The pin orientation of Q1, the 2N3906 (221334) transistor, is incorrect on your LABC1 circuit board (Rev 1.2). Please insert Q1 (step 17) with the flat side (no writing) facing the front of the board towards the D5-D14 diode matrix. Have fun building and enjoy your LABC1!

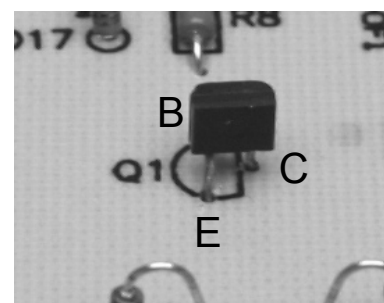
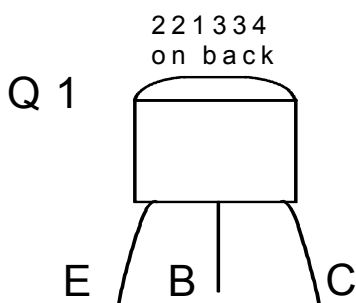
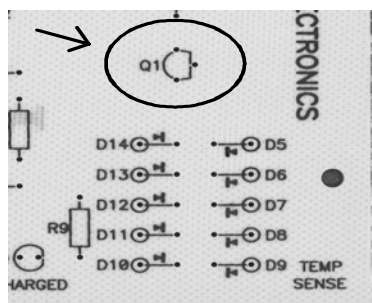
The pin orientation of Q1, the 2N3906 (221334) transistor, is incorrect on your LABC1 circuit board (Rev 1.2). Please insert Q1 (step 17) with the flat side (no writing) facing the front of the board towards the D5-D14 diode matrix. Have fun building and enjoy your LABC1!
